RE: Hugh Harris  
9 Sterling Road North  
Application for Site Plan and Wetland Permit Approval

RE: **Wetland Permit Approval**  
9 Sterling Road N.  
Sec. 108.02, Blk.1, Lot 58

September 28, 2021  
**Wetland Functional Assessment**  
**9 Sterling Road North**  
**Armonk, New York**

**MITIGATION/  
PLANTING PLAN**

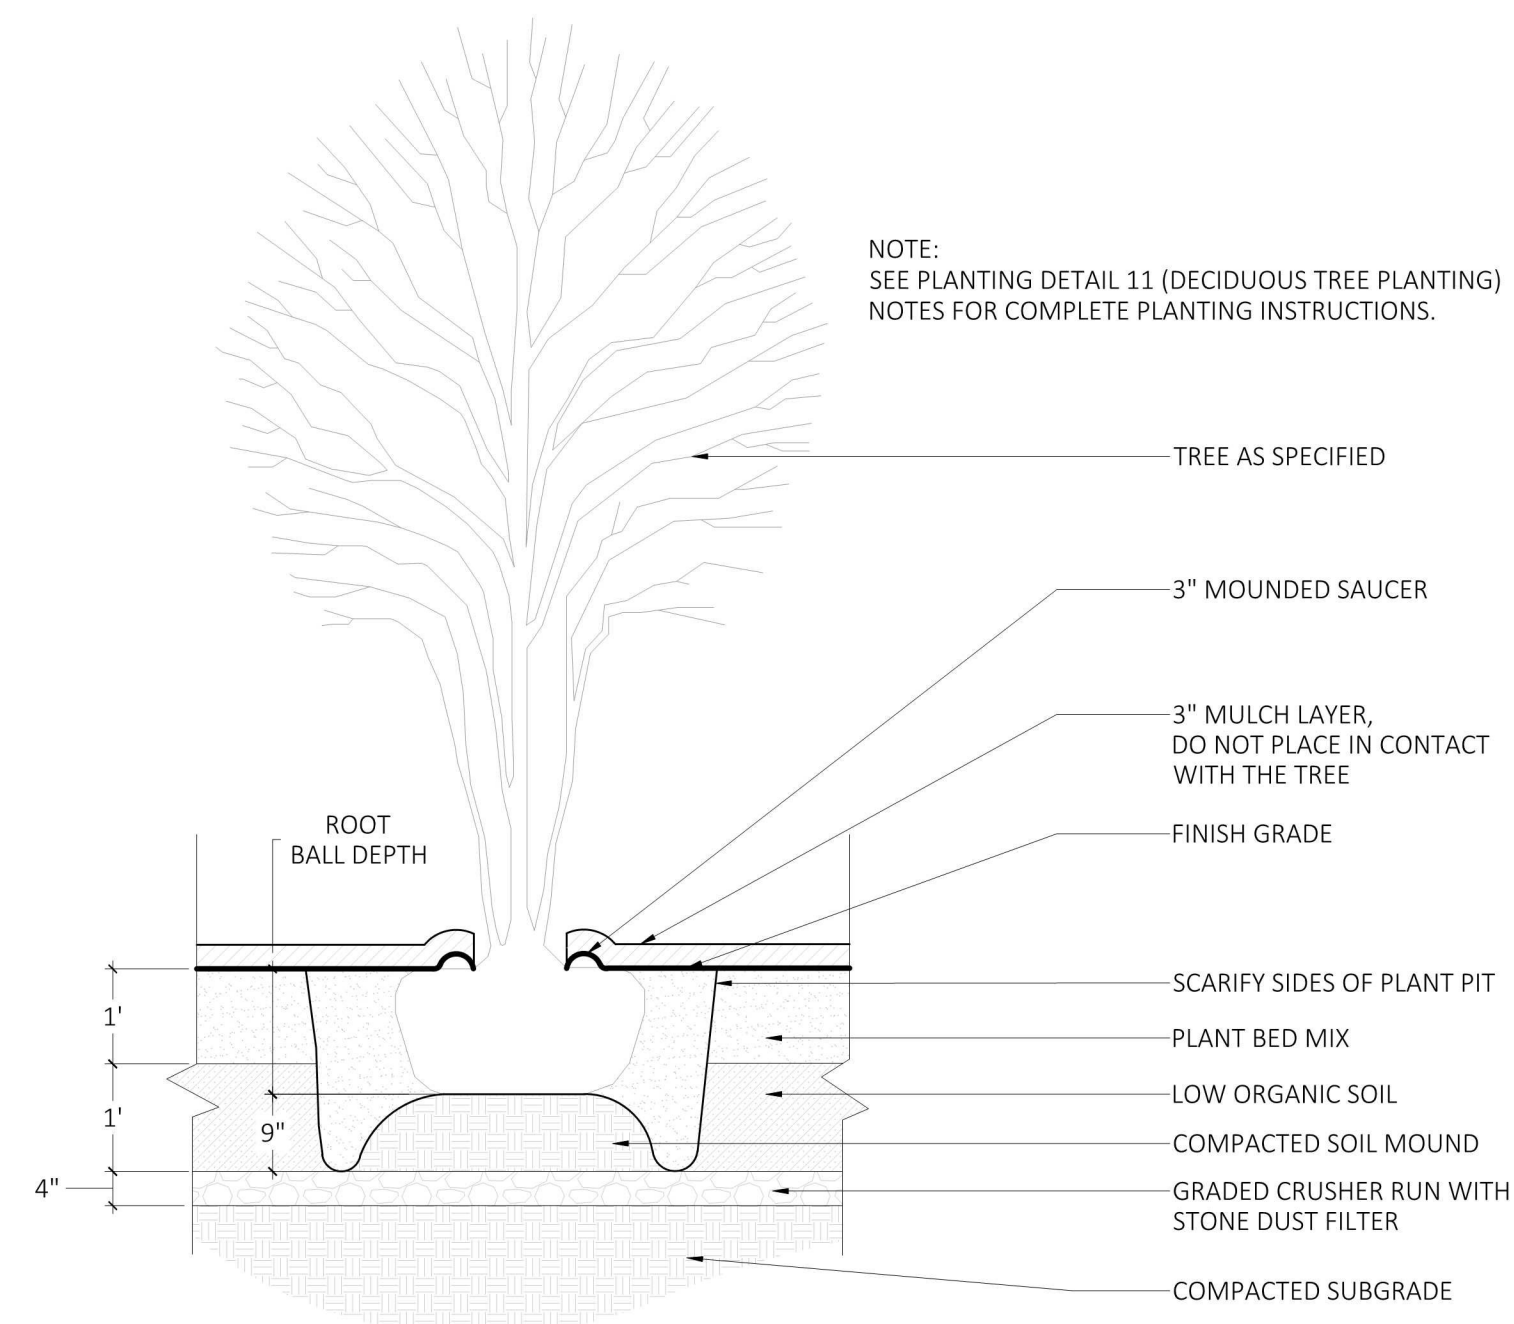
- 1) In general, the species chosen for the mitigation/planting plan are appropriate. However, Hamamelis Virgina (witch hazel) is a FAC- To FACU plant species, and may not do well planted within the wetland proper. It is recommended that an alternative native species more adaptable to wet soils be chosen for the wetland proper.
- 2) A project Long-term Wetland and Maintenance Plan, dated December 23, 2000, was reviewed and found by this office to be acceptable. Please remove the reference to "4 LedgeWood" within the report. A wetland/wetland buffer monitoring and maintenance shall be established, which should detail the completion of the mitigation plantings, as well as to ensure the maintenance of the plantings for a period of five (5) years.
